### **OUR CLIENTS: MR RICHARD GILL, MRS LISA GILL & DRONE DEFENCE SERVICES LTD SUBMISSIONS FOR DEADLINE 5**

# Cauntton Lodge Farm, Norwell Woodhouse.

Landscape Technical Note including Residential Visual Amenity  
Assessment (RVAA)

April 2026

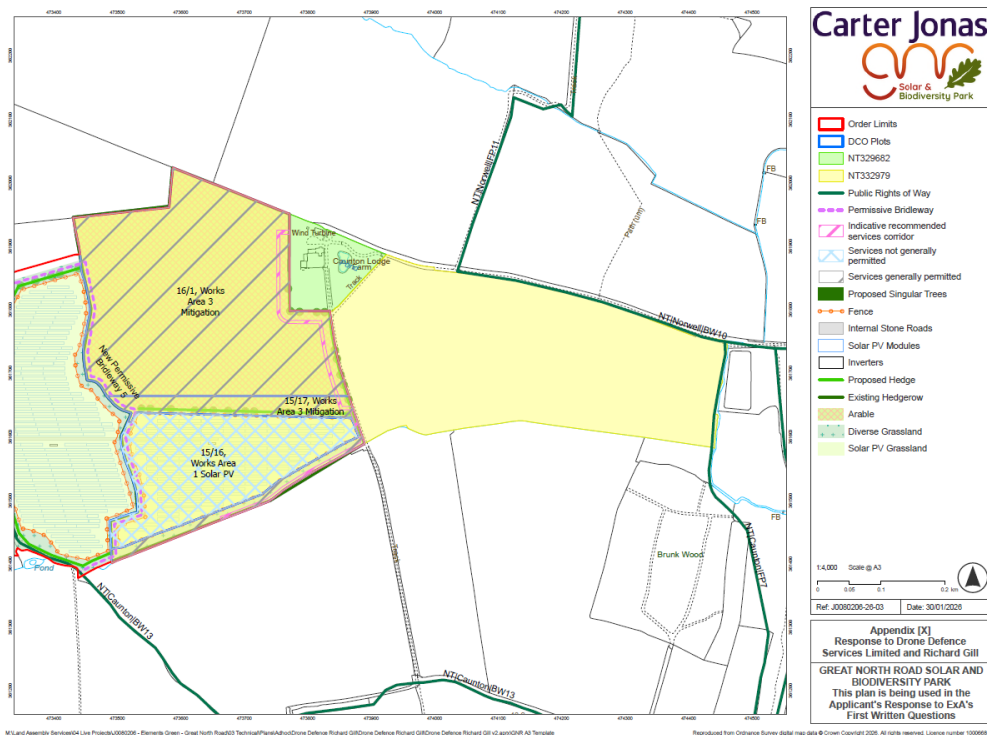
2.4.6 It is assessed that development features such as solar arrays, boundary fencing and pole mounted CCTV will be generally visible in proposed development areas as follows:

- a. Ground floor west facing windows – Development areas W18.1 and W18.3
- b. Ground floor south facing windows – Development areas W18.1 and W18.3
- c. First floor south facing windows – Development Area W18.3
- d. Inner terrace garden – Development Area W18.3

- e. South lawn – Development Areas W18.1 and W18.3
- f. West lawn – Development Areas W18.1 and W18.3
- g. East lawn and arrival area – Development Area W18.3
- h. Driveway - Development Area W18.3

### 3 EXISTING ASSESSMENT

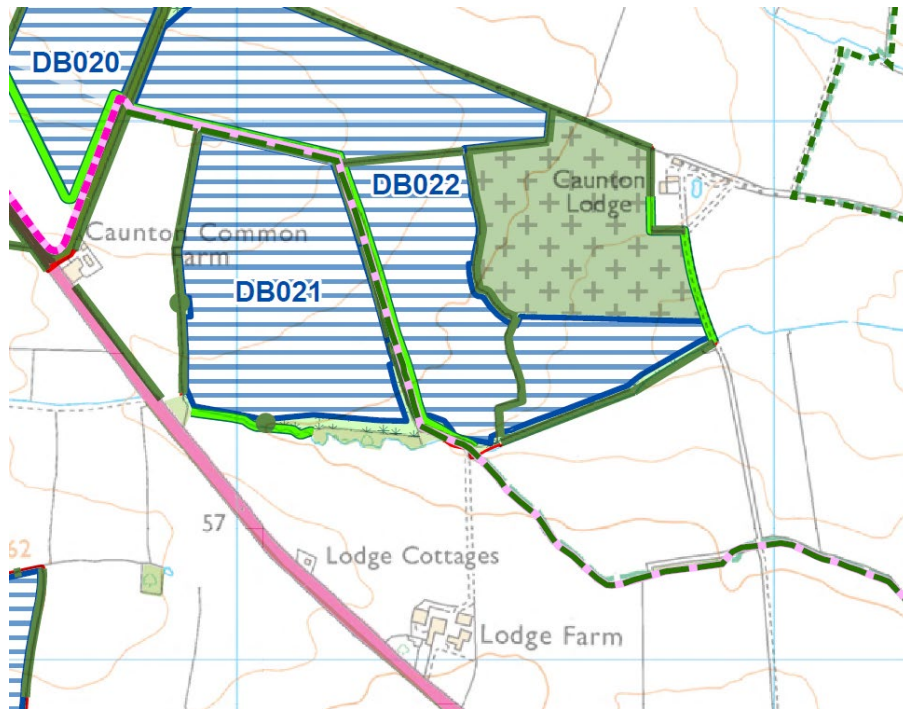
3.1.1 The GNR Solar and Biodiversity Park – Technical Appendix A7.6 Residential Visual Amenity Assessment includes an assessment of Caunton Lodge Farm. The property is referenced as R27: Caunton Lodge Farm and the assessment originally prepared in November 2024. The assessment is reproduced below and identifies a ‘Major Adverse’ level of effect arising from the development proposals.

3.1.2 Extract from November 2024 RVAA for Caunton Lodge Farm

<p>R27 Caunton Lodge Farm (240m south and west) See Sheet 5 for location</p>	<p>Caunton Lodge Farm is a large two-storey property accessed via private tracks. The property is set within a large, open garden that has hedgerows along the northern boundary and half of the western boundary. It has a small number of outbuildings and scattered trees. The primary aspects of the property face north and south, with the main outlook being to the south and southwest.</p> <p>There would be open views across the adjacent ecological mitigation area, towards the solar panels to the south and southwest from the access to the house, outer garden and windows in the south-facing gable end. Views from the main south-facing façade and small formal garden directly south of the house would be filtered through garden vegetation, but still relatively open, particularly in winter. The solar area would be on ground which gently slopes towards the property which would have the effect of making the Development appear slightly closer. Large/medium scale changes to views would arise for a Wide extent of the property.</p> <p>Preliminary RVAA Judgement: During all stages of the Development the magnitude of effects would be below the highest level of magnitude and effects would not reach the RVA threshold.</p>	<p>Magnitude: Large/medium</p> <p>Level of Effect Major, Adverse</p> <p>Assess at EIA Stage: Yes</p>

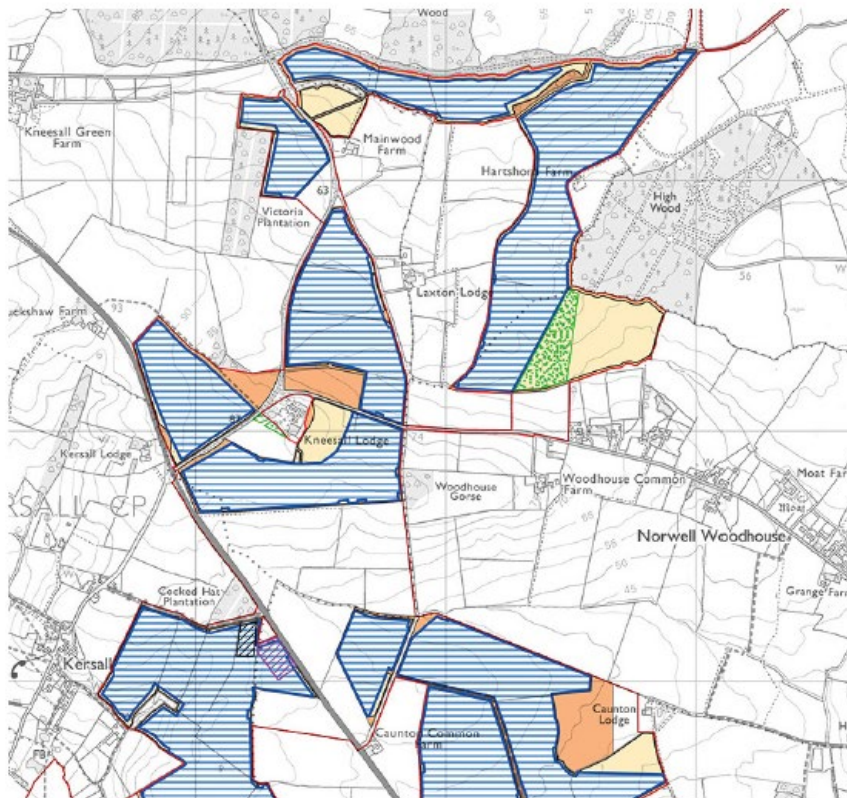
3.1.16 The Design Approach Document (EN010162/APP/5.6B) Revision 3 dated January 2026 sets out a number of examples where an iterative design approach has been used to address mitigation including relocation of solar arrays away from residential properties. The document presents the iterative design process that delivers the hierarchy of mitigation in accordance with EIA Regulations. Paragraph 5.2.1.2 Design Changes near Norwell Woodhouse records the process including the approach to mitigation at Caunton Lodge Farm. The extract below sets out the design actives which are illustrated on the plan extract.

**5.2.1.2 Design Changes near Norwell Woodhouse**

- Removal of one of the two potential areas for the Lime Lane intermediate substation to reduce visibility from the A616.
- Removal of solar panels south of High Wood from slopes facing towards Norwell Woodhouse and new woodland in the area to screen panels further west.
- Further set back of solar area to south of property at Cauntun Lodge and removal of panel areas north of Mainwood Farm and east and southeast of Kneesall Lodge in response to comments from householders during consultation in relation to visual amenity.

3.1.17 It can be seen that when applied correctly, the approach to mitigation ‘avoids’ potential adverse effects such as predicted at Mainwood Farm and Kneesall Lodge. This was achieved through the removal of solar arrays originally proposed at scoping and preliminary masterplan stages. However, at Cauntun Lodge Farm the design was adjusted but this adjustment did not address the nature of the harm or reduce the level of harm to residential amenity to less than major adverse. Visual harm was not avoided even with the introduction of secondary mitigation measures including hedge and tree planting.
